Re: Mesa del Sol Community Center Bldg A, 5700 W. University Blvd SE
Permanent Certificate of Occupancy - Approved
Engineer's Stamp dated 11/7/07 (R16/DA3005)
Certification dated 1/7/09

REFERENCE: Engineer's Certification for Community Center Building 'A' file **R16/D004**

ENGINEER'S CERTIFICATION FOR COMMUNITY CENTER BUILDING 'A' GRADING AND DRAINAGE PLAN

C-1 of 2

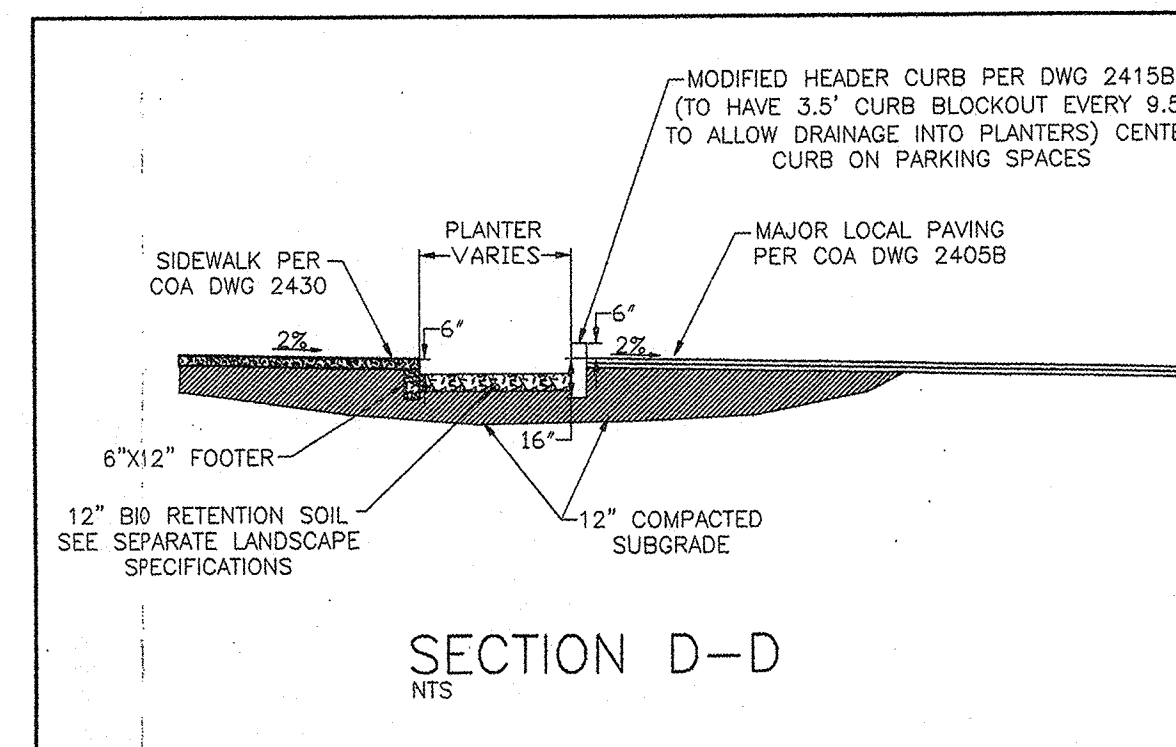
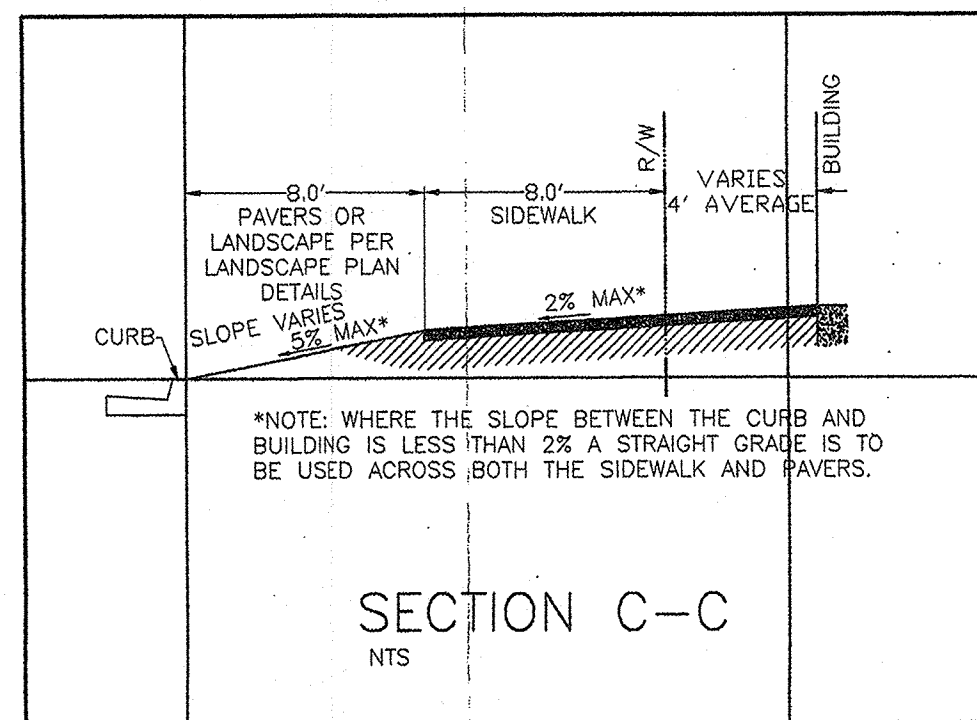
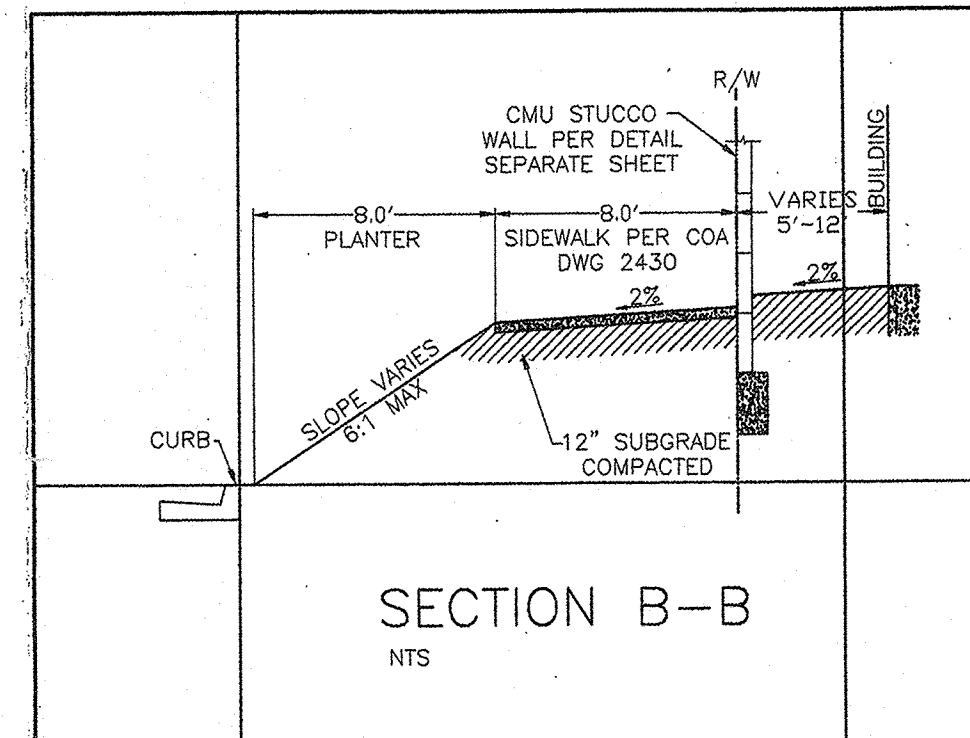
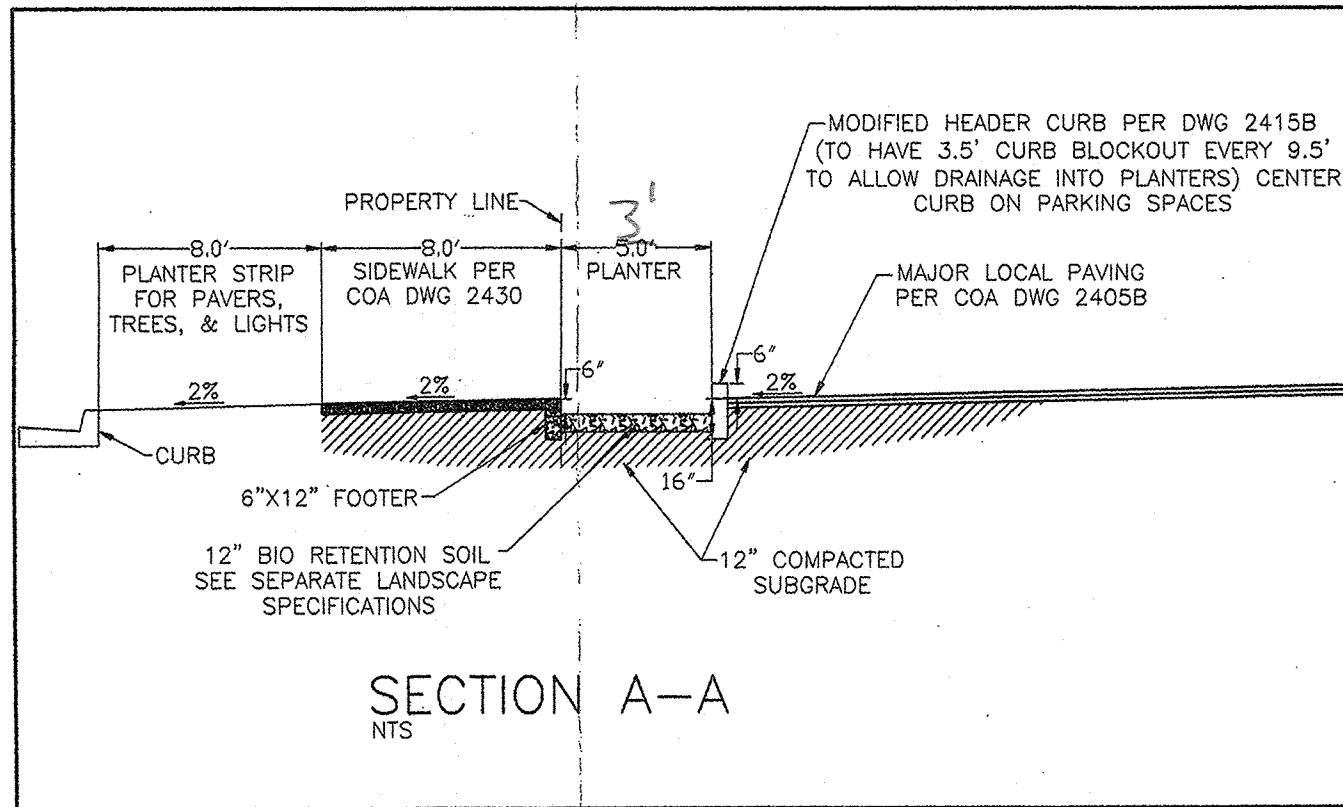
Remarks: Please consider approval of the Engineer's Cert. for 'Final CO even though the owner is just seeking Temp CO on his Building Permit. That would save everyone time later. The four comments in letter dated Dec. 19, 2008 have been addressed as follows:

- Inlet #4 and the landscaping on either side had recently been lowered about 4" to conform to section AA on sheet C-2 and the originally planned grate elevation shown on sheet C-1. The inlet grate was missing on 1/6/2009.

- Striker landscape and Inlet #4 grate were lowered to prevent drainage across the sidewalk.
- Construction activity complete and ready to open to the public.
- Certification is changed to plan dated 11-7-07.
- As-built elevations are circled, Limits of Certification are added to plan view, and previous deviations were either reconstructed or were moved to areas of future certifications under separate building permits.
